TRANS/WP.29/2003/5
12 December 2002

PROPOSAL FOR DRAFT SUPPLEMENT 15 TO REGULATION No. 54

(Pneumatic tyres for commercial vehicles)

Transmitted by the Working Party on Brakes and Running Gear (GRRF)

Annex 3, amend to read:

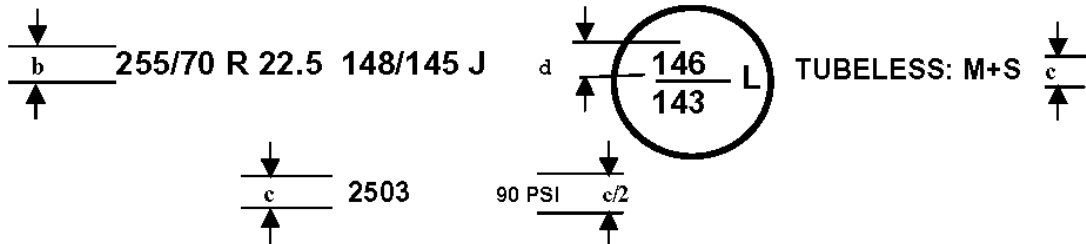
"Annex 3

ARRANGEMENT OF TYRE MARKINGS

MINIMUM HEIGHTS OF MARKINGS (mm)	
	Tyres of nominal rim diameter < 508mm (Code 20) or of nominal section width ≤ 235mm (Code 9)	Tyres of nominal rim diameter ≥ 508mm (Code 20) or of nominal section width > 235mm (Code 9)
b	6	9
c	4	
d	6

1. These markings, given as an example, define a pneumatic tyre:

2. In the particular case of tyres having a tyre to rim fitment configuration "A", the marking shall be in the form of the following example:

3. The positioning and order of the markings constituting the tyre designation shall be the following:
